## DEVELOPMENT SERVICES *Staff Report*

REPORT NO: DS 2021-027

SUBJECT: Draft Plan of Subdivision Application 30T-21601  
Zone Change Application 07/21  
Snyder's Road (Baden) GP Inc. / MHBC  
Part of Lot 16, Concession North of Snyder's Road  
1012 Snyder's Road West, Baden

DRAFT PLAN OF SUBDIVISION

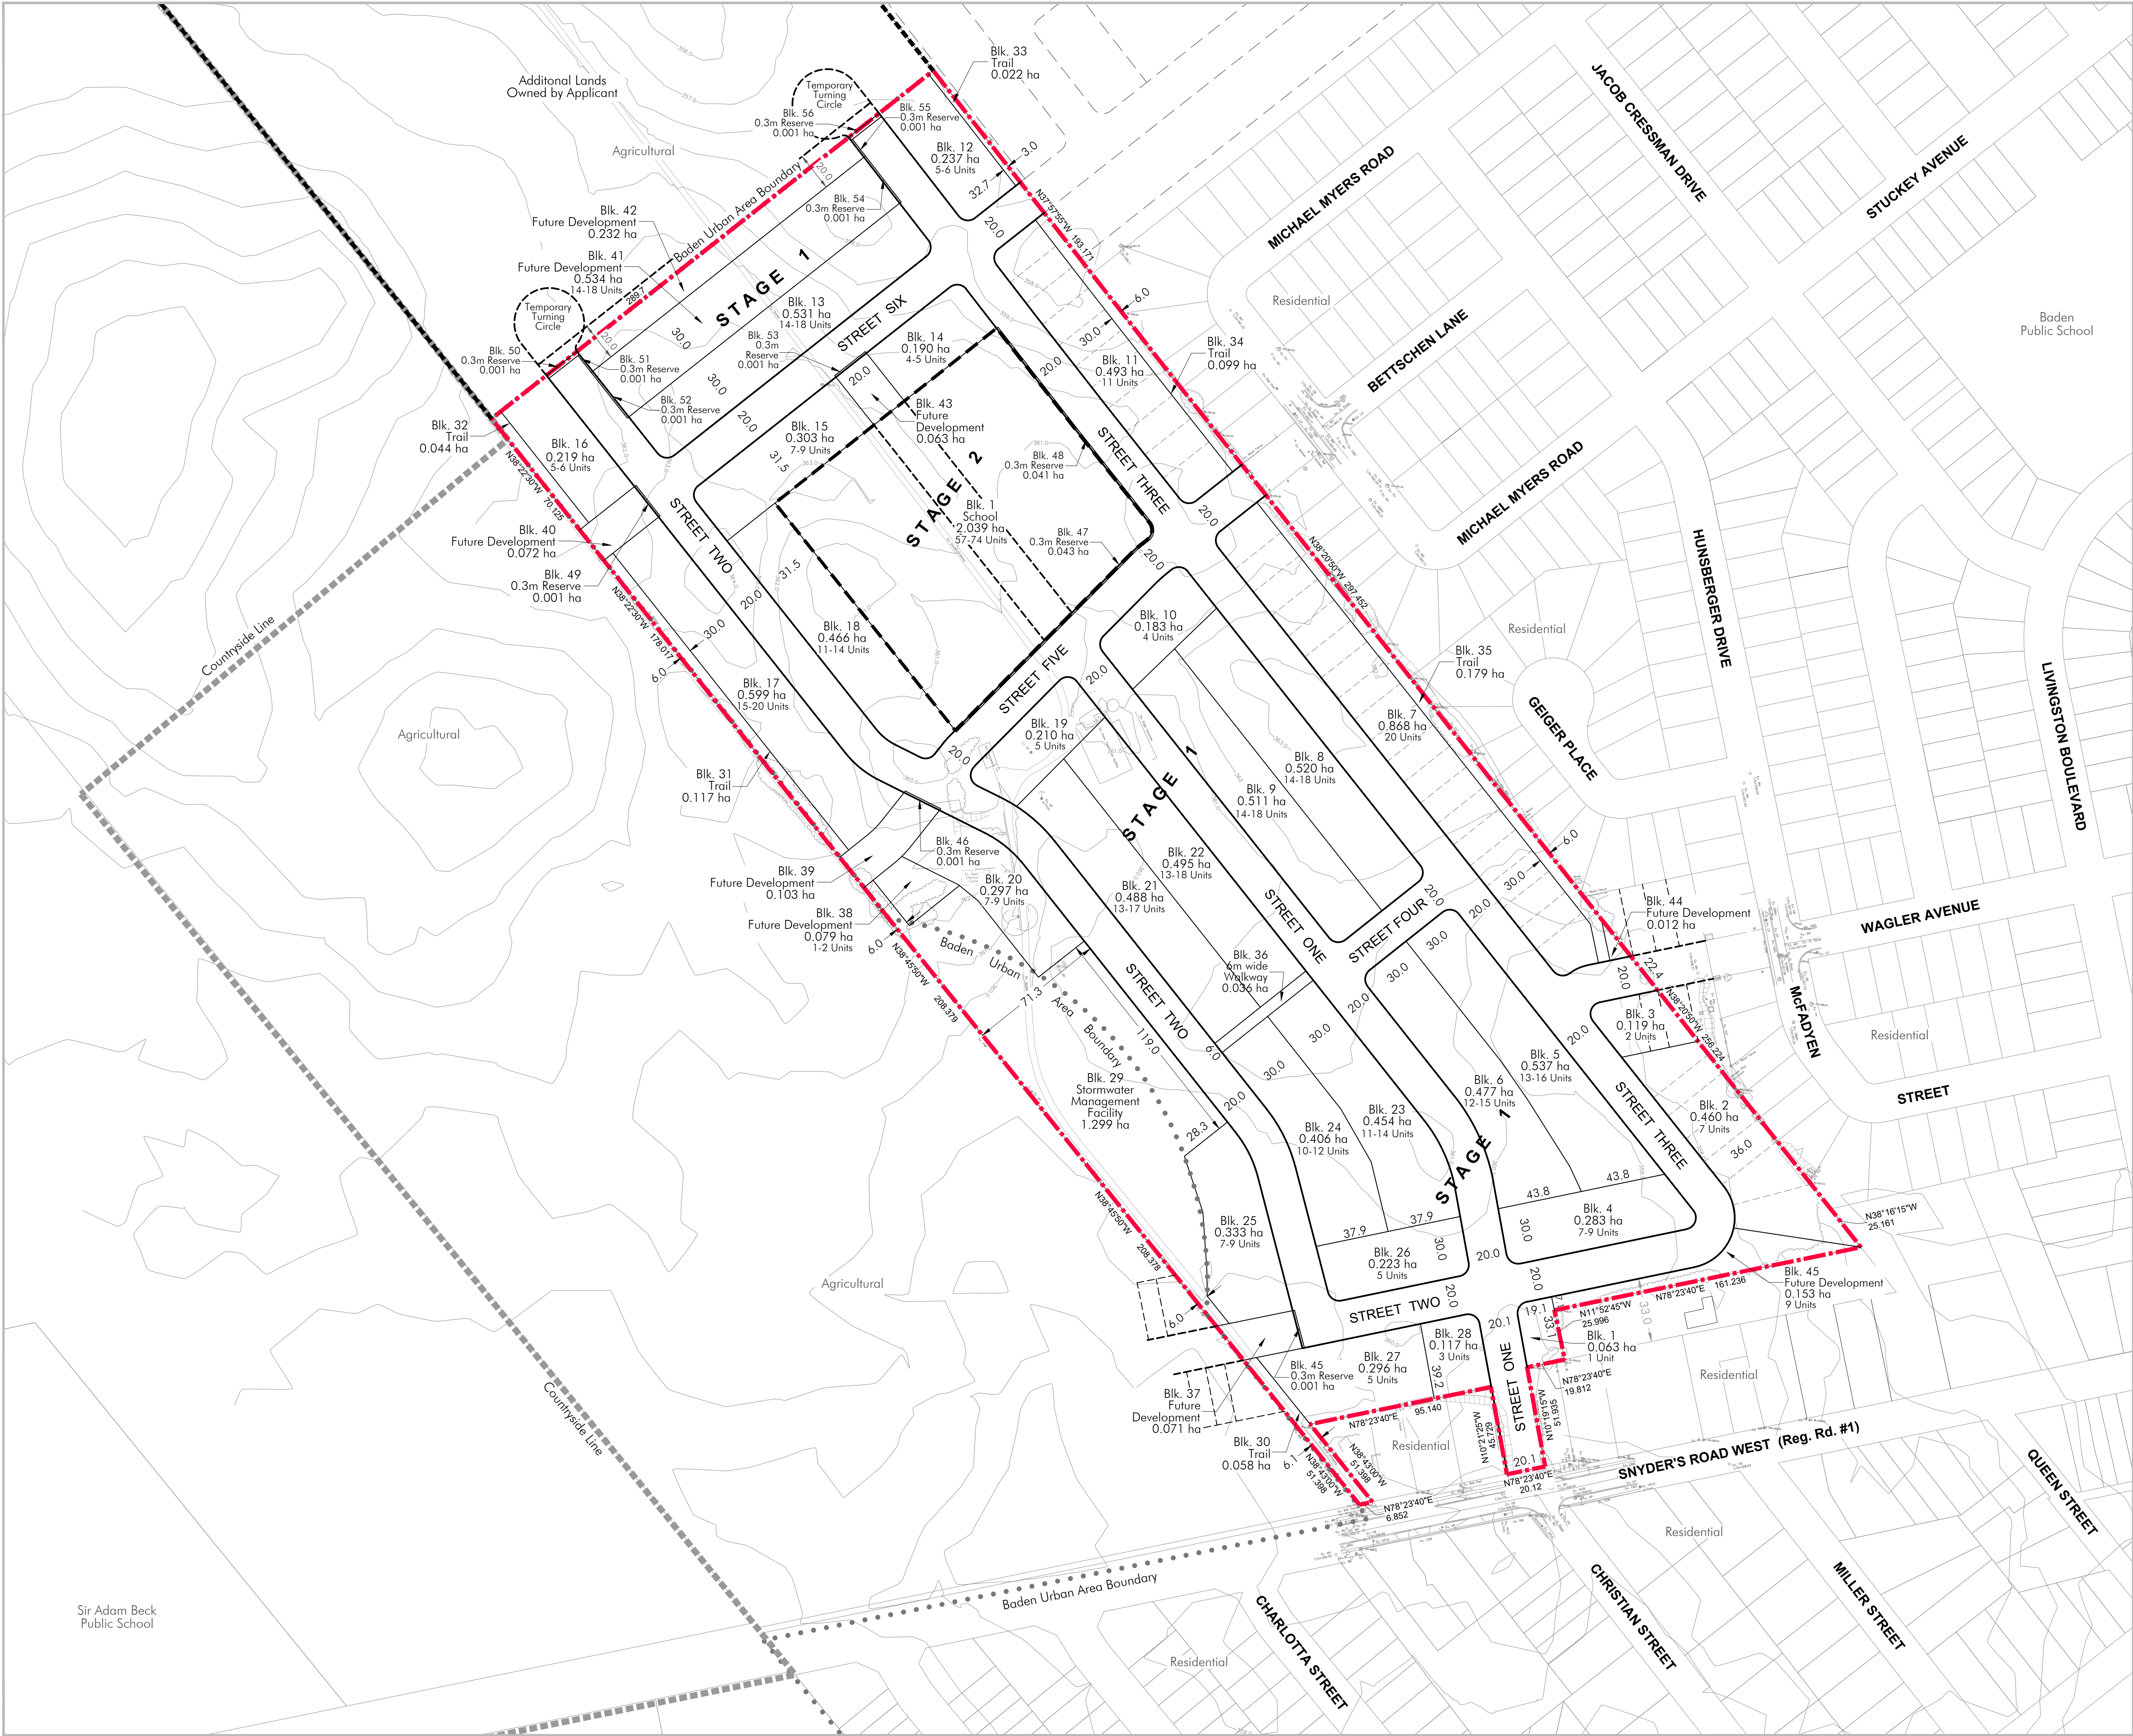
- 1) There is no walkability or active transport in the entire south and south-east corner of the proposed development. Reference pg 20-21 of "Urban Design Brief". We know kids going to high school will flow out of the existing community via the Wagler entrance to this new development and walk street three to shortcut to highschool. There should be consideration for this. Sidewalks and or natural walking paths.

- 2) There are zero parks or recreational space in the first phase unlike the adjacent development. There might be a plan for parks & recreational space in the next Phase but that is unacceptable, it should be built in to each phase of development. Reference pg 16-17 of "Urban Design Brief". Recommendation. Use the southeast corner of the development (BLK. 2) be an ideal spot for park or green space as it would be adjacent to BLK. 45 under future development review and is a very sharp corner in the plan. This would also buffer the existing homes and the only area where there is no walking path to buffer the existing homes from the new development.

- 3) My residence is ■■■ McFadyen St. Currently there is a large 6m easement in the back of the property. All the runoff from the current development property currently exits to my property and flows south to the drain behind 35 McFadyen St. There are a number of incidences annually where the flow of water is 1-2 feet deep and runs like a river through the easement. My concern is this should be changed during the construction

and proper drainage should be put in place between the new development and my property to address residential drainage. Additionally the easement should be removed or shrunk to an appropriate size with proper grading redone by the township & developer.

- 4) If there is no change to add a natural walking path along Street three in the south east corner (BLK.2) we would recommend that there be tall coniferous trees put in place to buffer the existing homes from the development which will take place over a number of years. Ideally, 6ft apart and 10-15ft in size. This will block dirt and dust and provide some relief from the construction noise and the unappealing view.
- 5) There should be no construction vehicles allowed down Livingston or McFadyen St. or Wagler Street during development. Recommendation: the west side road entrances should be blocked and/or have speed bumps to discourage this.
- 6) There should be a 4 way stop put in the corner of Wagler & McFadyen/Hunsberger to calm the flow of future traffic.

**Q4) The plan calls for 2 access points one of which goes through either Wagler or Bettchen. The traffic through our community would be unsafe as there are many children who play in our area. One access post from Snyders Road would create a safer access point for our community.**

Figure 6  
**Proposed Zoning  
By-law Amendment  
Schedule**

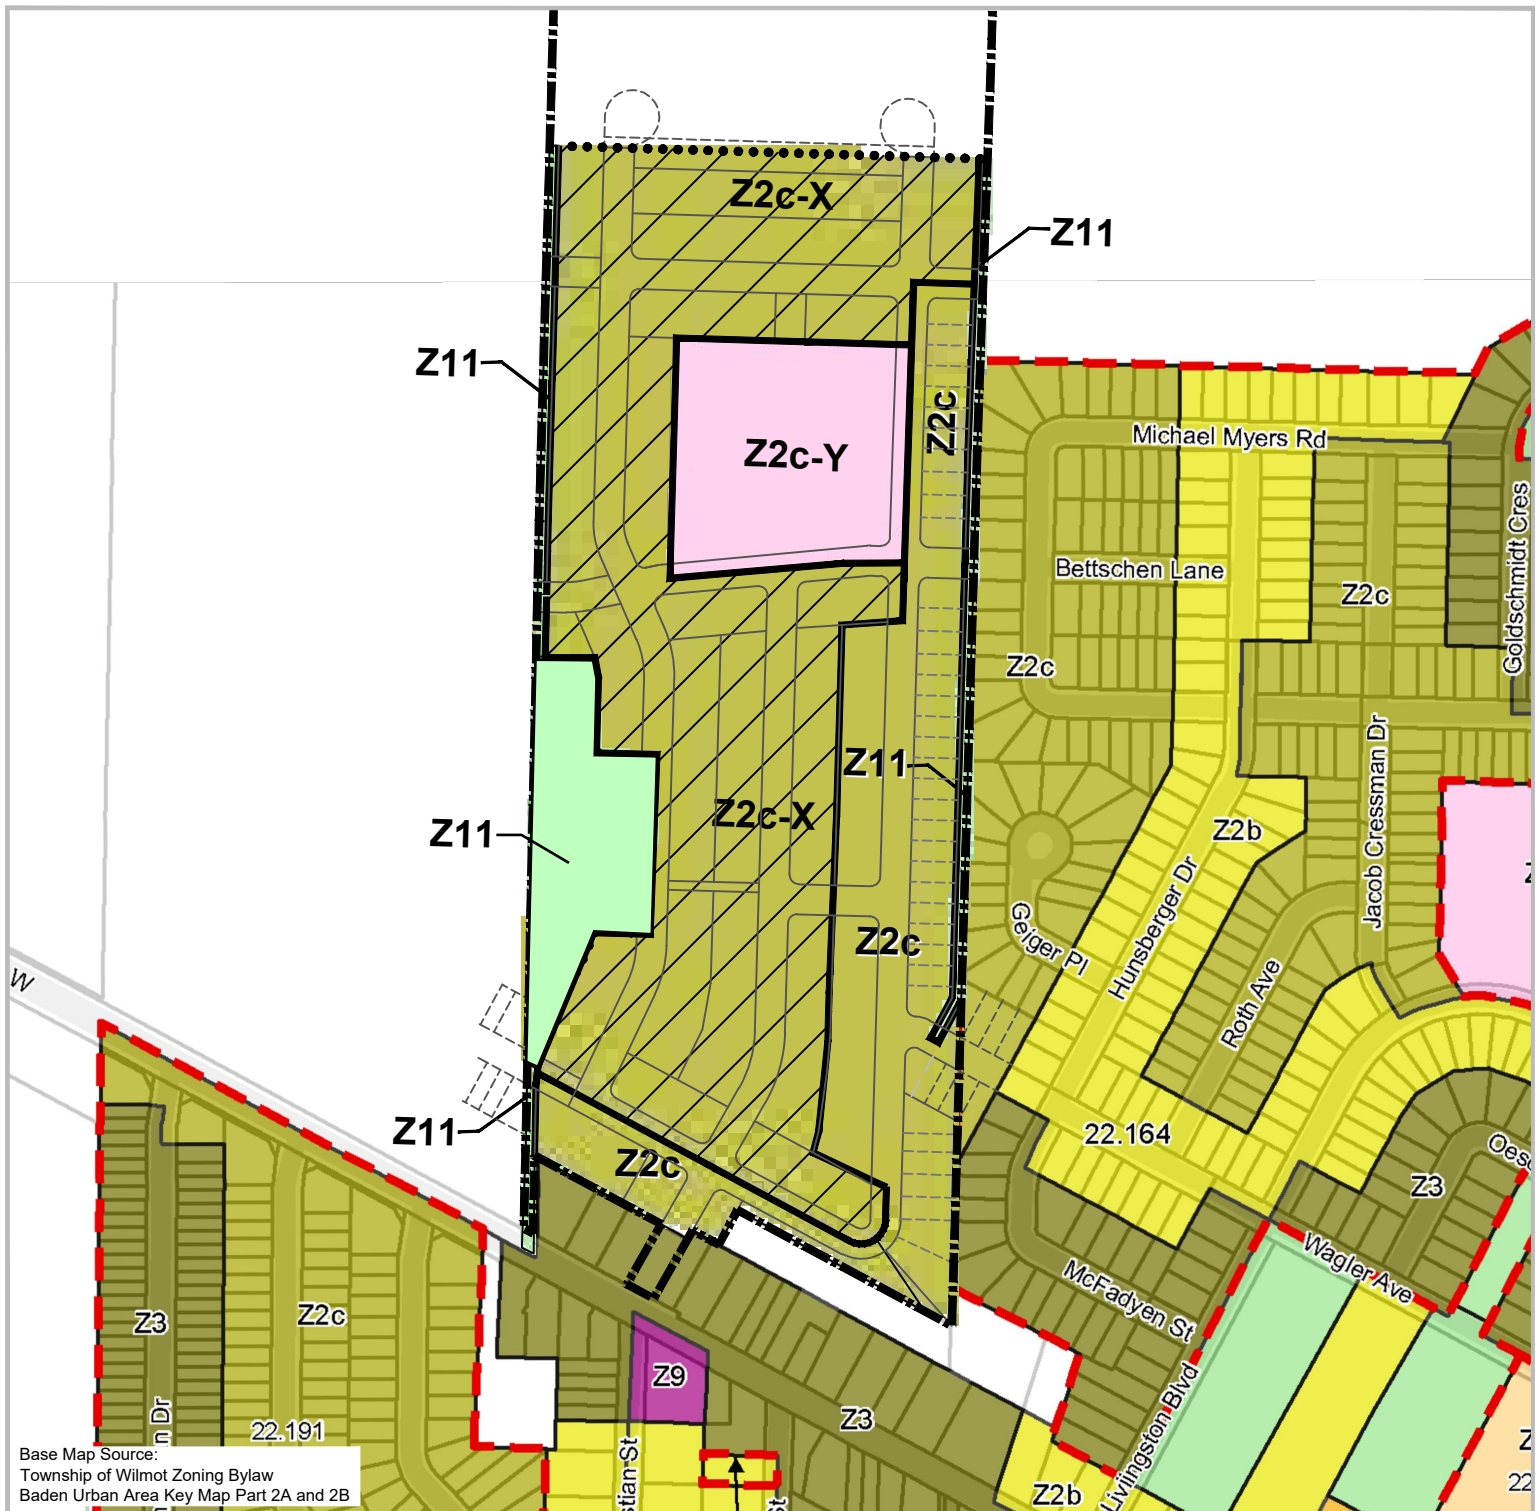
**Q1) AREA Z2C Please explain to us “Accessory uses including second dwelling units” behind Michael Myers Road and Geiger Place and McFadyen**

**Q3) Area Z11 The 6 meter path between Michael Myers Road and Geiger Place and McFadyen and the proposed subdivision, we recommend a greater width that buffers the previous development (which provided 3 meters of land for this buffer from the previous developer Eastforest Homes) and the new developer, to a minimum of 12 meters where the new developer provides the additional 8 meters of trail use.**

- If I read “figure 6” (Proposed Zoning by-law Amendment schedule) correctly, I believe the new subdivision will be land locking some land that is currently zoned Agricultural behind some houses on Snyder’s Rd. W. Wouldn’t this be a good time to re-zone this land so you don’t have land in the middle of Baden that is zoned agricultural?
- Will any of the property owners that border this new subdivision be responsible for any cost of the new roads that border their property? (eg. 160 Snyder’s Rd., W., Baden)
